Access Compliance Report

Public Rights-of-Way

Intersection ID: 24400	Main Street: FRESHWELL_RD	Cross Street: POPPLETON_CT	Location: SE
ADA ID: 4A76FF90A615	Ramp Type: PerpDiag	Initial Pass/Fail: Pass	Overall Compliance: No
		Severity Score: 10

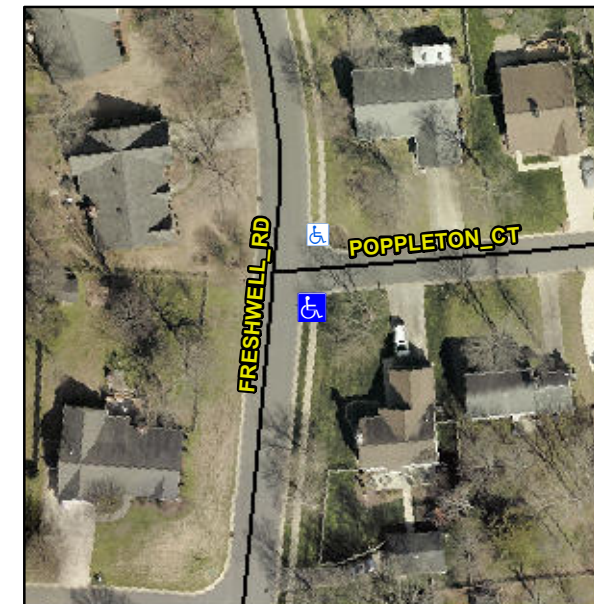
Not Found, R304.2.1, R304.2.2-Perp, R304.3.2-Para, R304.5.3, R305.2

Remove & Replace Curb Ramp With Two New Directional Ramps or Equivalent.
